N1055A-01

# Modification Recommended Service Note

## N1055A - 35/50 GHz 2/4 Port TDR/TDT Remote Sampling Head for the 86100D DCA-X

Serial Numbers: MY00000000-MY57200000

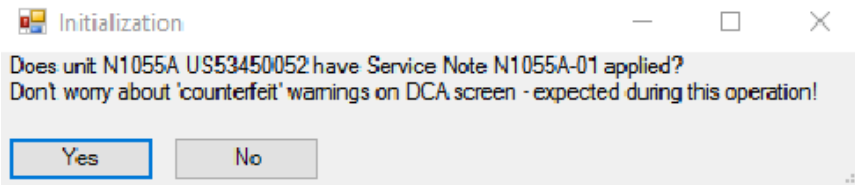
- 1) After repair with a new style sampler board, label (PN N1055-80022) shall be placed on the

central groove of the module body top rail as shown below:

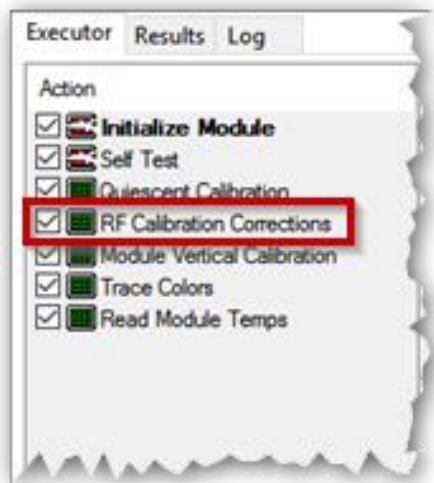
- 2) "N1055A-01" shall be added to the comments field of the unit's memory. When applicable, the N1055A test code will ask if this service note has been executed and update the comments field accordingly. Select 'Yes' if new-design boards are installed:

In most cases, manual editing of the comments field is not required. If necessary, the comments field may be altered using Service Mode and is found in the System Debug window. Existing comments should not be overwritten; text should be appended instead.
